H11704

## DESCRIPTIVE REPORT

*General Locality* ..... Chatham Strait

*Sublocality* ..... Chaik Bay

**Figure 2 Profile of 2K04-TIE01**

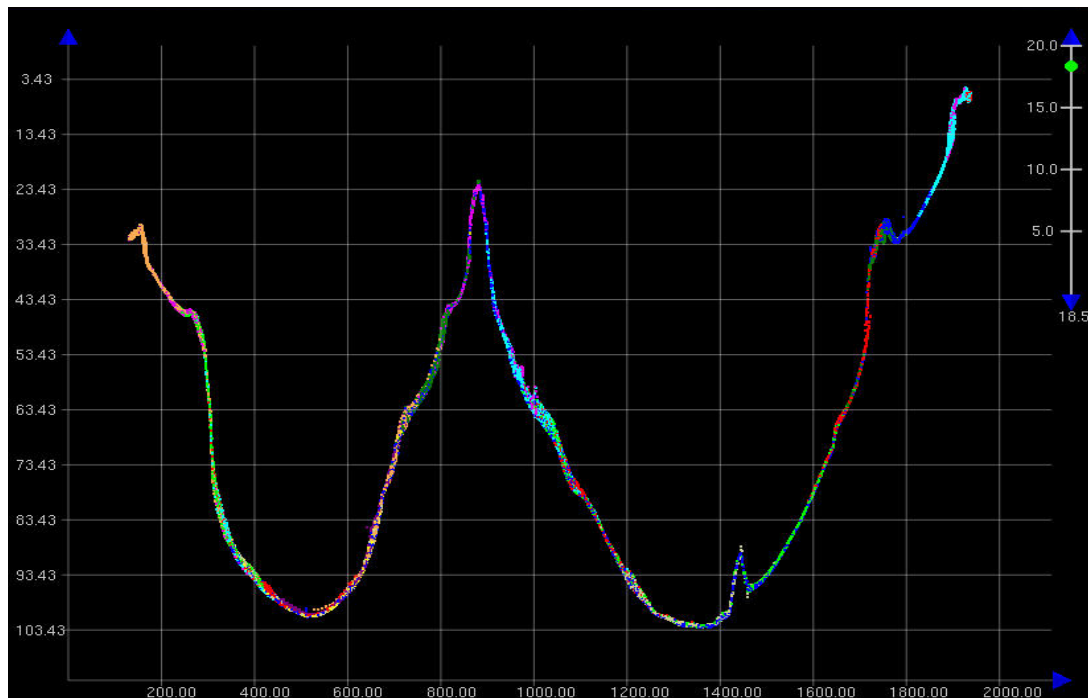
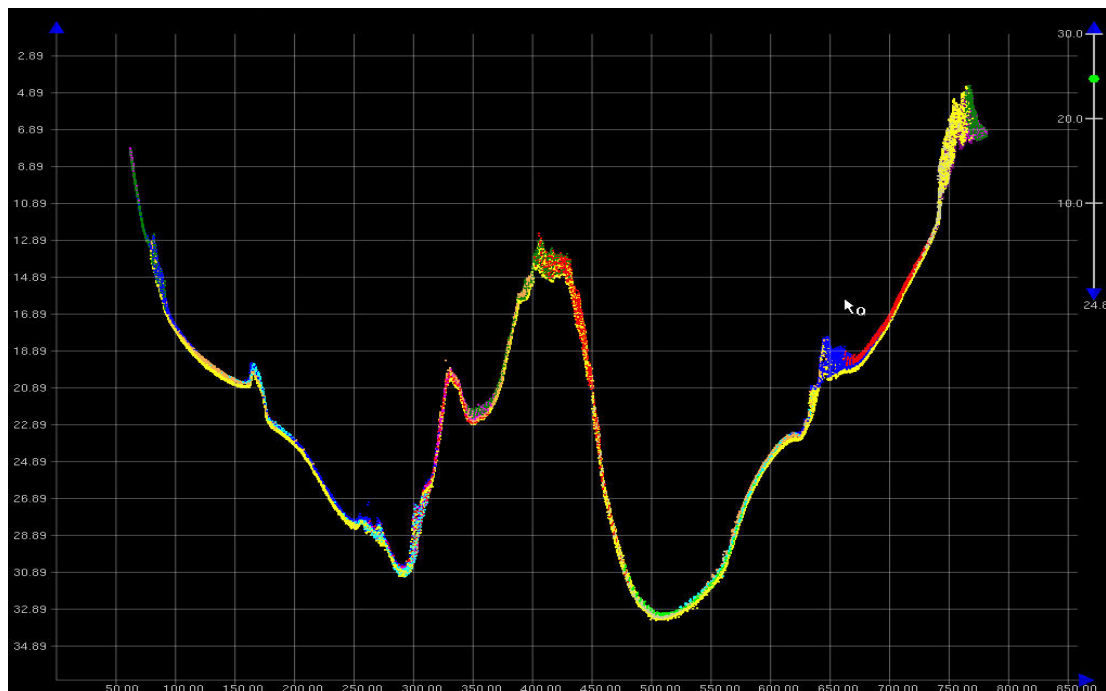
The majority of QC Reports fall well within the required accuracy specifications. However, beams that fall below the 95 percent confidence level in the QC report are associated with areas and conditions illustrated below. It should be noted that these locations are in agreement with the surrounding adjacent lines and are considered well within the required specifications.<sup>3</sup>

The majority of beams that fall below the 95 percent confidence level are located in areas having extremely steep slopes and/or rocks. Figures 2 and 3 below provide examples.

- <sup>2</sup> Filed with project records.
- <sup>3</sup> Concur.
- <sup>4</sup> Concur.
- <sup>5</sup> During compilation, a junction was made with H11699, H11702 and H11705, all of which have been compiled and submitted.

**Figure 4 H11704 Uncertainty DTM**

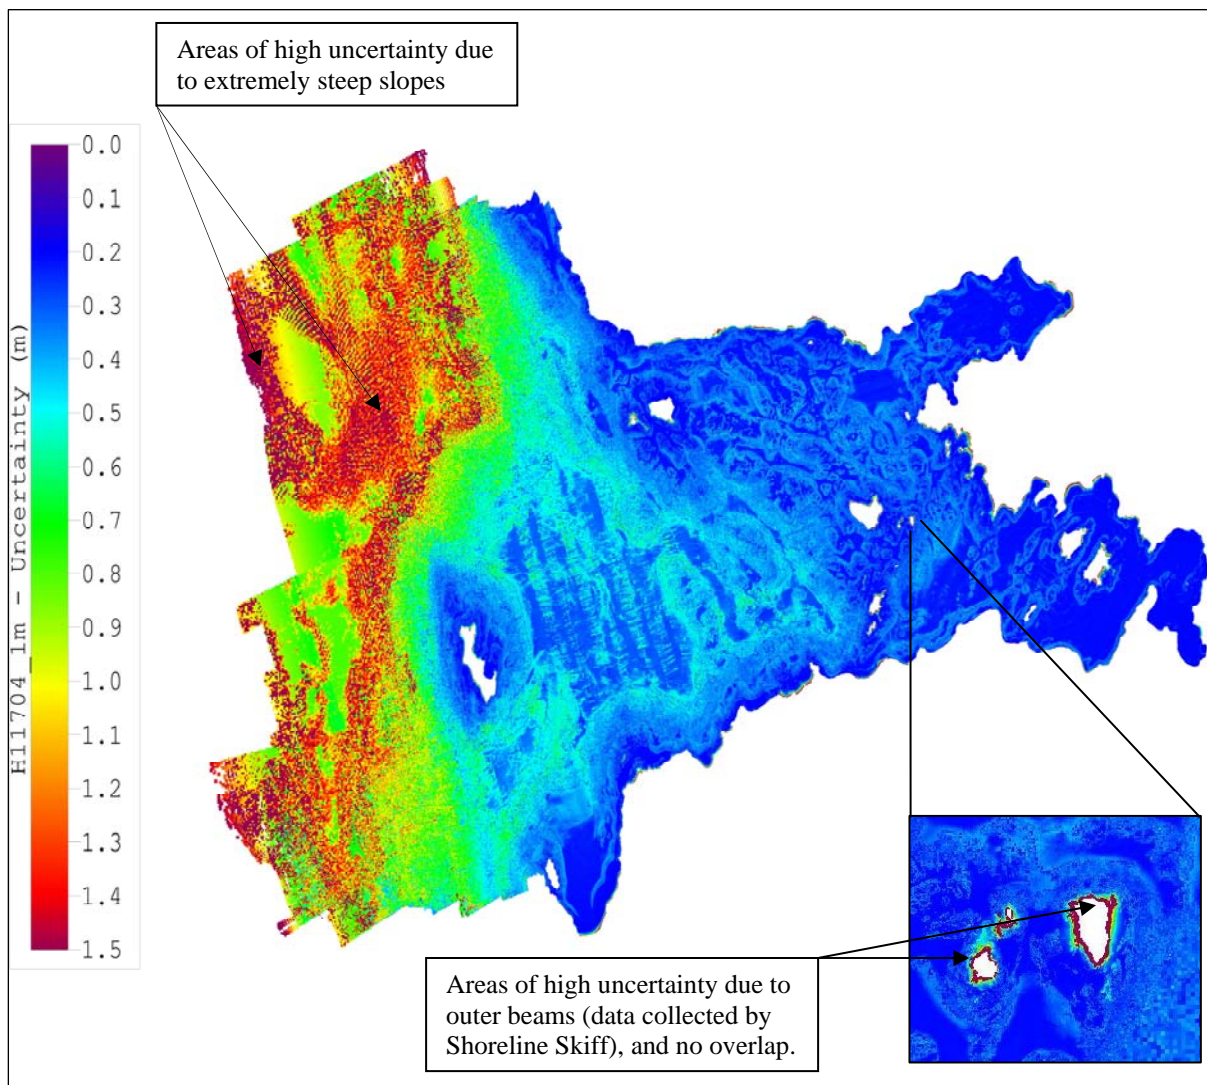
The majority of H11704 had an uncertainty of about 0.20 to 0.50 meters, except for the deep water areas having extremely steep slopes or deemed to be rocky, where values ranged from 0.7 to 1.5 meters. Another exception to this is found in the nearshore areas in water depths of 1 to 2 meters where the uncertainty values ranged from 1.5 meters and higher, due to outer beams and no overlap. No uncertainty values were greater than the IHO level Order 1.<sup>4</sup>

**Figure 5 H11704 Survey Junctions**

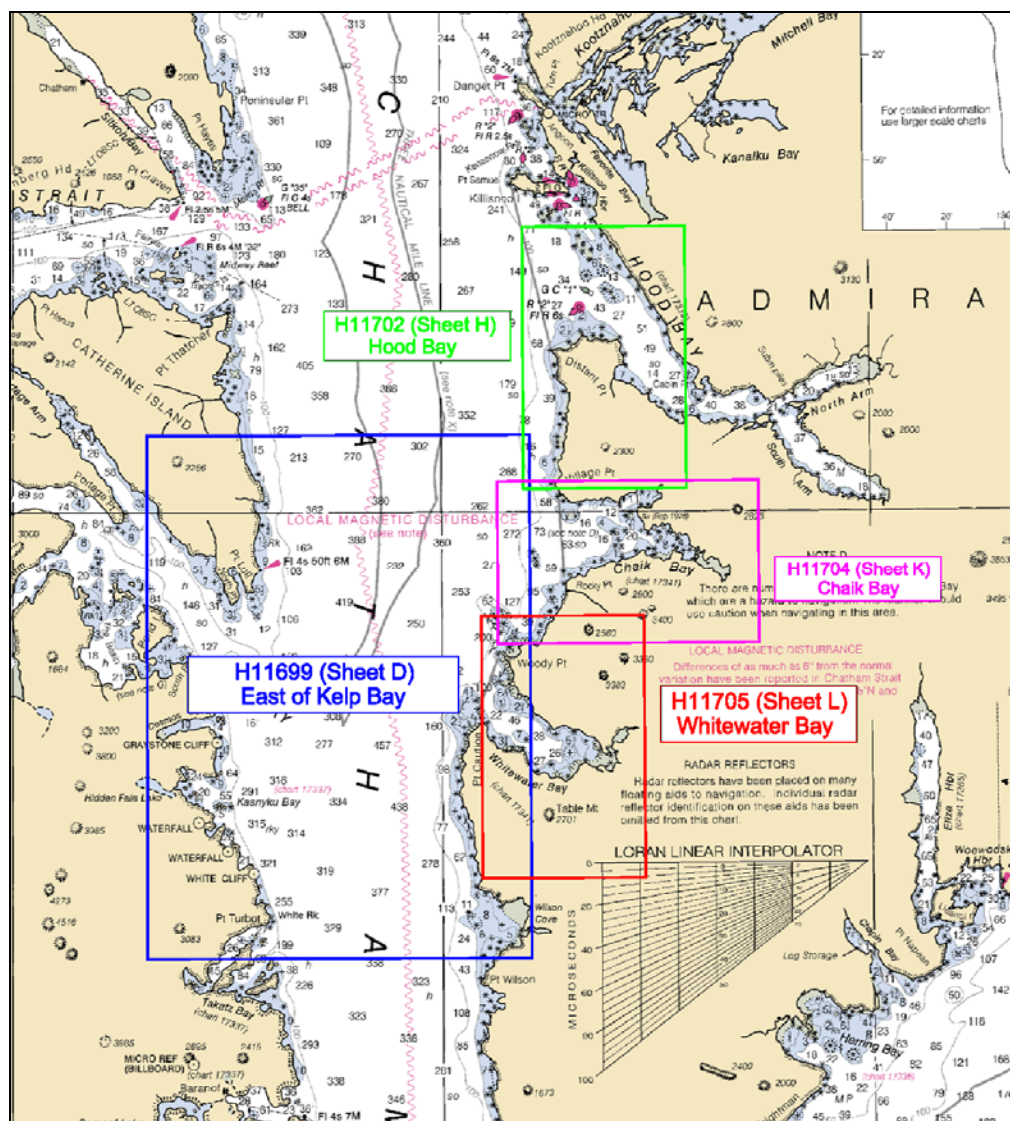
H11704 (Sheet K) junctions with:<sup>5</sup>

The surveys are in agreement along their common borders. The agreement was noted in the field using the CARIS CUBE surfaces during subset cleaning. The conformity is also apparent in the final combined BASE surfaces.<sup>6</sup>

- <sup>6</sup> Concur.
- <sup>7</sup> Concur.
- <sup>8</sup> Concur with clarification. A 15m combined surface was created during the Survey Acceptance Review and was the basis of compilation. See Survey Acceptance Review Checklist.

**Figure 6 H11704 Chart Comparison (Chart 17341)**

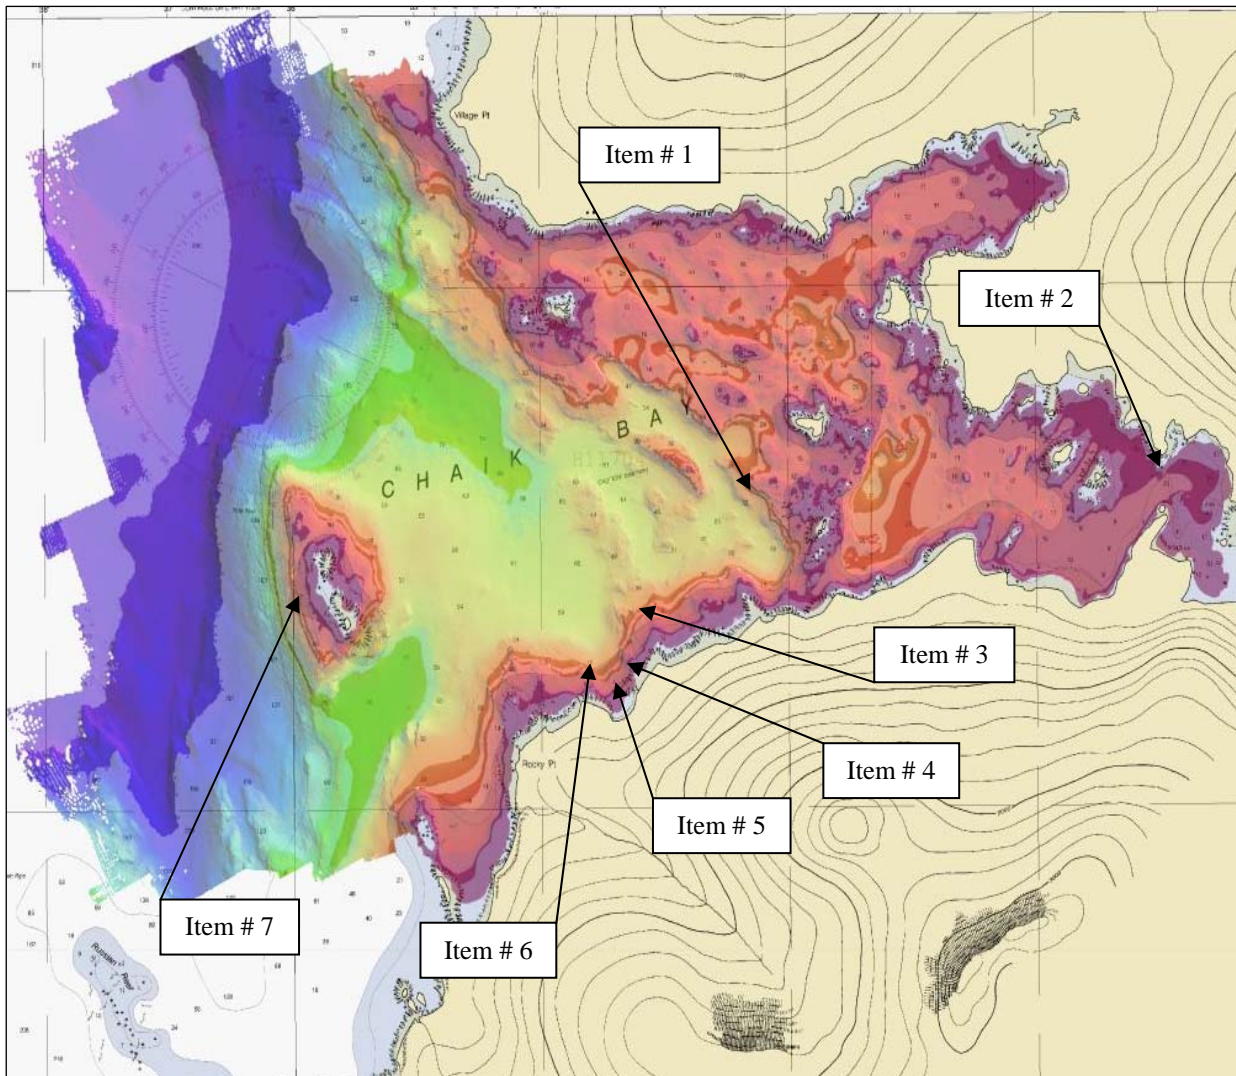
In general, the soundings from chart 17341 coincide with the soundings from H11704 to within 1 to 5 fathoms; areas that do vary to any degree are as follows;<sup>14</sup>

- Item # 1: Hydrographic survey H11704 revealed a depth of 43 fathoms in the vicinity of a 35 fathom sounding on chart 17341 located at 57°19'13" N, 134°32'20" W. This area was surveyed with 100% multibeam coverage.

- Item # 2: Hydrographic survey H11704 revealed a depth of 10 fathoms in the vicinity of a 2 ¾ fathom sounding on chart 17341 located at 57°19'13" N, 134°28'56" W. This area was surveyed with 100% multibeam coverage.

- Item # 3: Hydrographic survey H11704 revealed a depth of 33 fathoms in the vicinity of a 20 fathom sounding on chart 17341 located at 57°18'44" N, 134°33'16" W. This area was surveyed with 100% multibeam coverage.

- Item # 4: Hydrographic survey H11704 revealed a depth of 23 fathoms in the vicinity of a 7 ½ fathom sounding on chart 17341 located at 57°18'34" N, 134°33'21" W. This area was surveyed with 100% multibeam coverage.

- Item # 5: Hydrographic survey H11704 revealed a depth of 17 fathoms in the vicinity of a 1 ½ fathom sounding on chart 17341 located at 57°18'28" N, 134°33'23" W. This area was surveyed with 100% multibeam coverage.

- Item # 6: Hydrographic survey H11704 revealed a depth of 35 fathoms in the vicinity of a 17 fathom sounding on chart 17341 located at 57°18'33" N, 134°33'36" W. This area was surveyed with 100% multibeam coverage.

- Item # 7: Hydrographic survey H11704 revealed a depth of 19 fathoms in the vicinity of a 7 fathom sounding on chart 17339 located at 57°18'49" N, 134°35'56" W. This area was surveyed with 100% multibeam coverage.

- <sup>13</sup> Do not concur. ENC US3AK3BM is based on Chart 17320 and covers the entire survey area.
- <sup>14</sup> Concur with clarification. Compiler agrees with field chart comparison and additional discrepancies found during the Survey Acceptance Review. See SAR checklist.

**Figure 7 H11704 Electronic Chart Comparison (Chart US3AK3BM)**

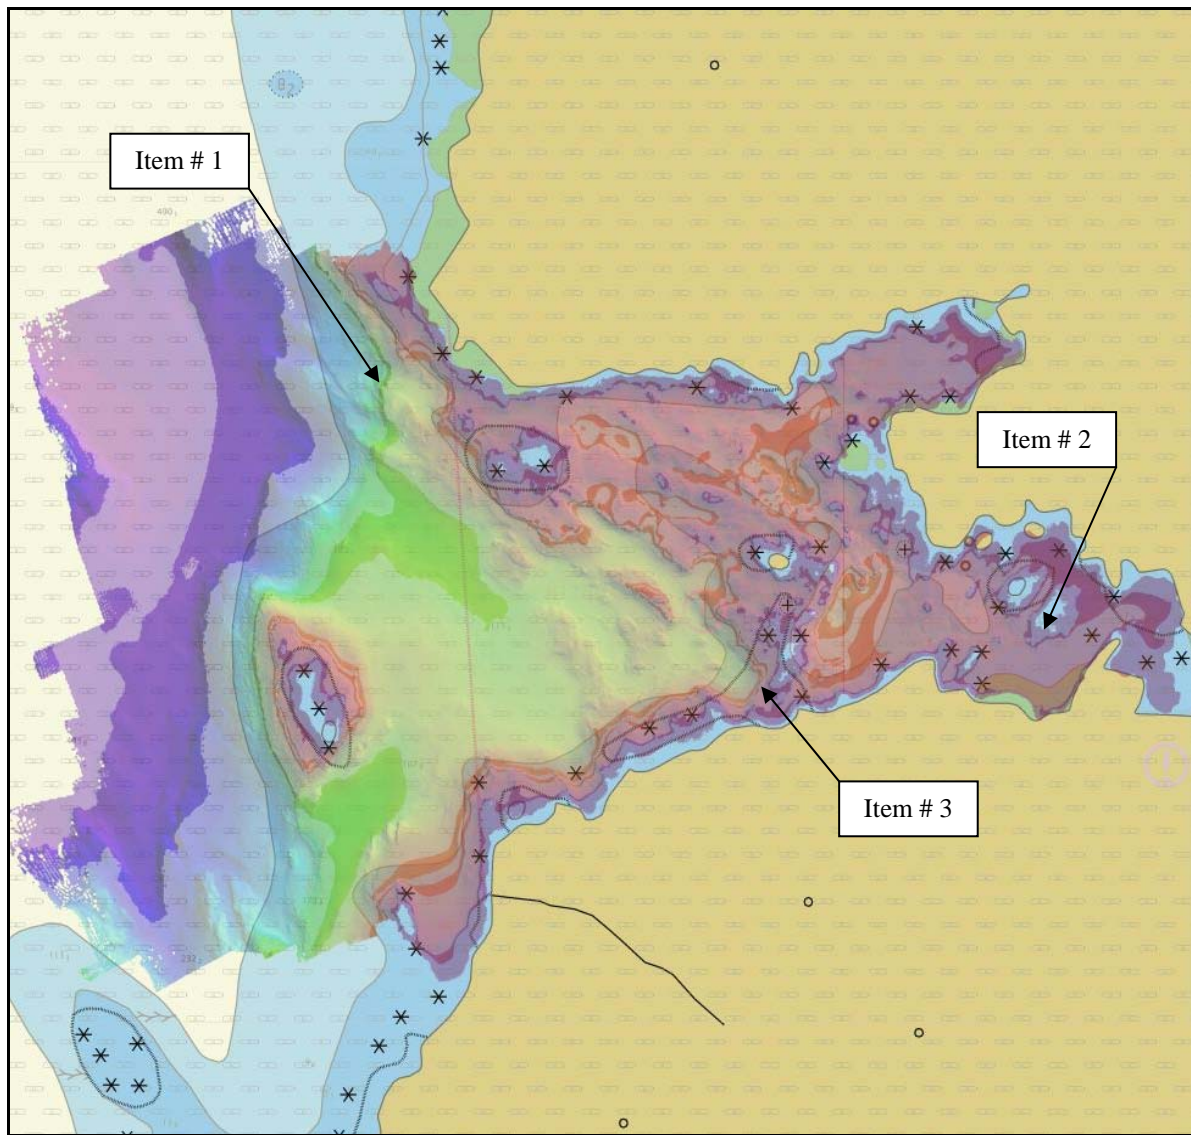
In general, the soundings from electronic chart US3AK3BM coincide with the soundings from H11704 to within 5 to 15 meters; areas that do vary to any degree are as follows:<sup>16</sup>

- Item # 1: Hydrographic survey H11704 revealed a depth of 153 meters in the vicinity of a 106 meter sounding on electronic chart US3AK3BM located at 57°20'15" N, 134°35'07" W. This area was surveyed with 100% multibeam coverage.
- Item # 2: Hydrographic survey H11704 revealed a depth of 1.4 meters in the vicinity of a 14.6 meter sounding on electronic chart US3AK3BM located at 57°19'10" N, 134°29'33" W. This area was surveyed with 100% multibeam coverage. Suggest moving the sounding more offshore, as it is located in sparse data.
- Item # 3: Hydrographic survey H11704 revealed a depth of 34 meters in the vicinity of a 1.8 meter sounding on electronic chart US3AK3BM located at 57°18'56" N, 134°31'55" W. This area was surveyed with 100% multibeam coverage.

- <sup>15</sup> Concur. Compiler agrees with hydrographer's chart comparison. Supersede charted data in the common area.
- <sup>16</sup> Concur. Compiler agrees with hydrographer's chart comparison. Supersede charted data in the common area.
